Access Compliance Report Public Rights-of-Way (Curb Ramps)

Intersection ID: 24395Main Street:BIRNEN_DRCross Street:KINGS_FALLS_DRLocation:SWADA ID: 5C85F26CC44DRamp Type:PerpDiagInitial Pass/Fail:FailOverall Compliance:NoSeverity Score:10

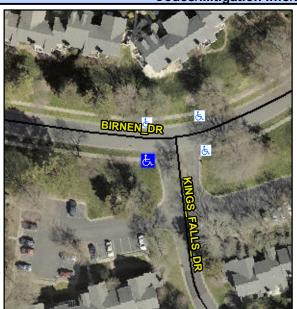
Not Found, R304.5.1, R304.5.3

Compliance Description		Data	Compliance Description		Data
N/A	Ramp Length (in)	44.0	Yes	Ramp Slope (%)	6.4
No	Ramp Width (in)	46.0	No	Ramp XSlope (%)	3.5
N/A	Flare Type LT	N/A	N/A	Flare Type RT	N/A
N/A	Flare Slope LT (%)	N/A	N/A	Flare Slope RT (%)	N/A
N/A	Flare Traversable LT?	N/A	N/A	Flare Traversable RT?	N/A
N/A	Landing Length (in)	N/A	N/A	DWS Provided?	N/A
N/A	Landing Width (in)	N/A	N/A	DWS Contrast?	N/A
N/A	Landing Slope (%)	N/A	N/A	DWS Length (in)	N/A
N/A	Landing X Slope (%)	N/A	N/A	DWS Full Width?	N/A
N/A	Landing Curb? (Y/N)	N/A	N/A	DWS Offset (in)	N/A
N/A	Shared Landing?	N/A			
N/A	Gutter Ponding?	N/A	N/A	Gutter Slope (%)	N/A
N/A	Gutter Lip Ht (in)	1.0	N/A	Gutter X Slope (%)	N/A
N/A	Painted X Walk1?	No	N/A	Painted X Walk2?	No
	X Walk 1 Direction	To E		X Walk 2 Direction	To N
N/A	X Walk 1 Width (in)	N/A	N/A	X Walk 2 Width (in)	N/A
	X Walk 1 Slope (%)	1.2		X Walk 2 Slope (%)	1.5
	X Walk 1 X Slope (%)	2.0		X Walk 2 X Slope (%)	3.1

Remove & Replace Curb Ramp With Two New Directional Ramps or Equivalent.
